STATE OF CONNECTICUT
CONNECTICUT SITING COUNCIL

SBA TOWERS III/NEW CINGULAR
WIRELESS PCS, LLC APPLICATION FOR A
CERTIFICATE OF ENVIRONMENTAL
COMPATIBILITY AND PUBLIC NEED
FOR A TELECOMMUNICATIONS FACILITY
LOCATED AT WEWAKA BROOK ROAD
BRIDGEWATER, CONNECTICUT

DOCKET NO. 412

SBA TOWERS III (“SBA”) AND NEW CINGULAR WIRELESS PCS, LLC (“AT&T”)
RESPONSES TO TOWN OF BRIDGEWATER INTEROGATORIES

ATTACHMENT 2

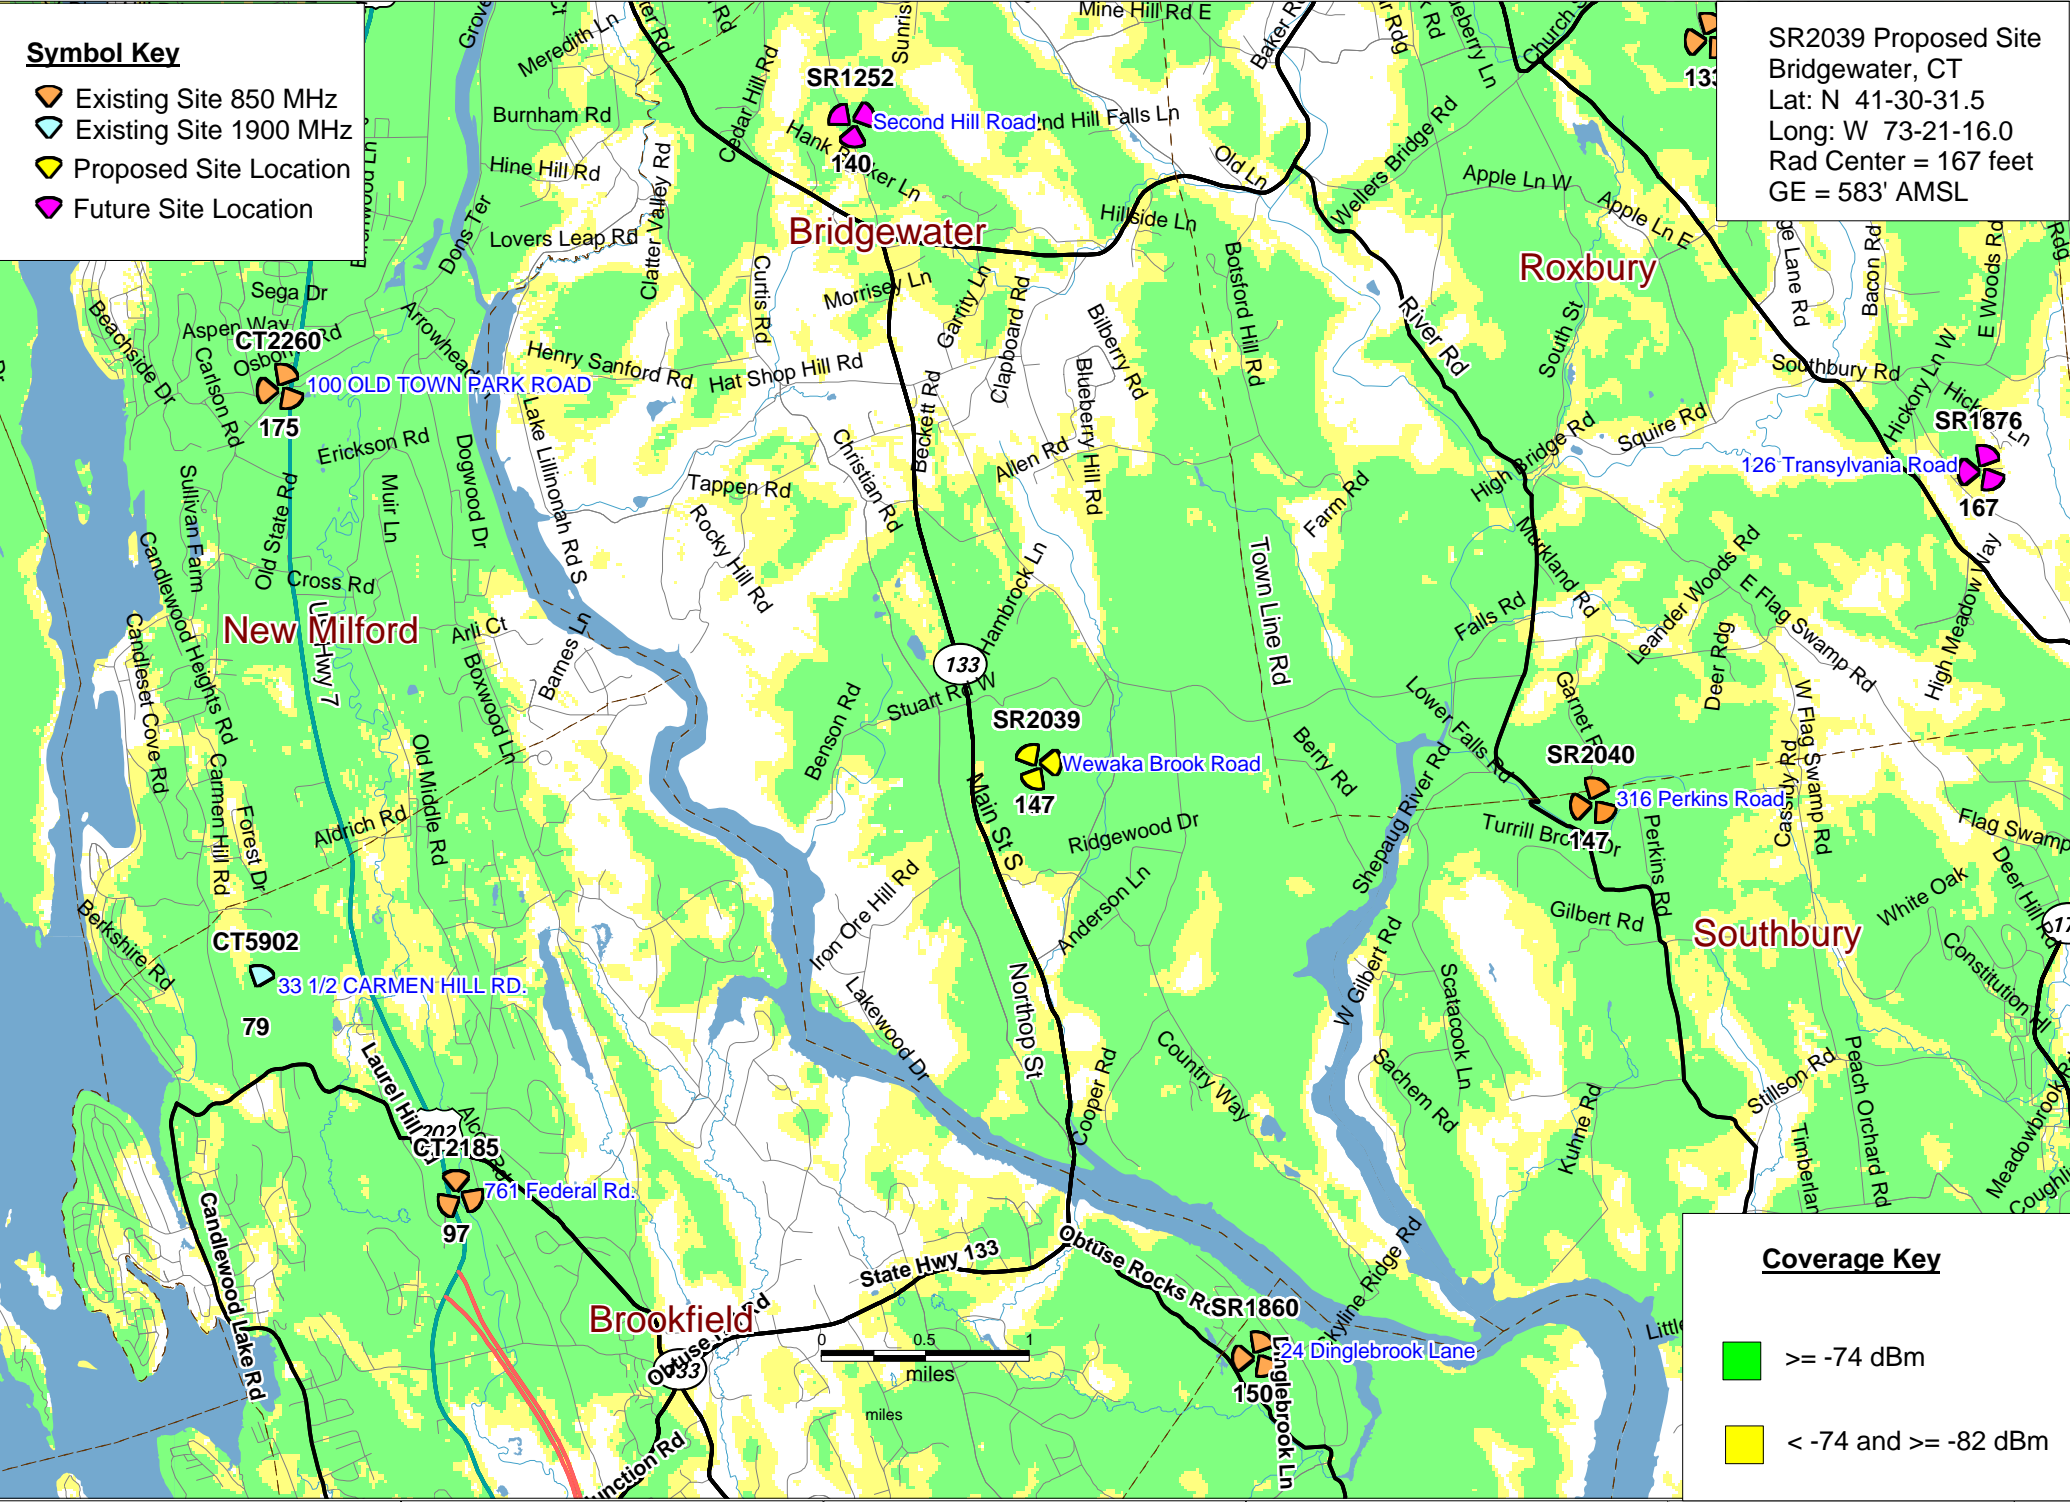
Q5. Were drive tests (“scan test”) that would verify the results of the calculated plots conducted? If so, please provide the data sets which were generated by the tests and note whether the data needs to be corrected for variables including, but not limited to, antenna position, gain and line loss.

A5. A drive test of existing coverage was performed. A plot of this drive test is included in Attachment 2.
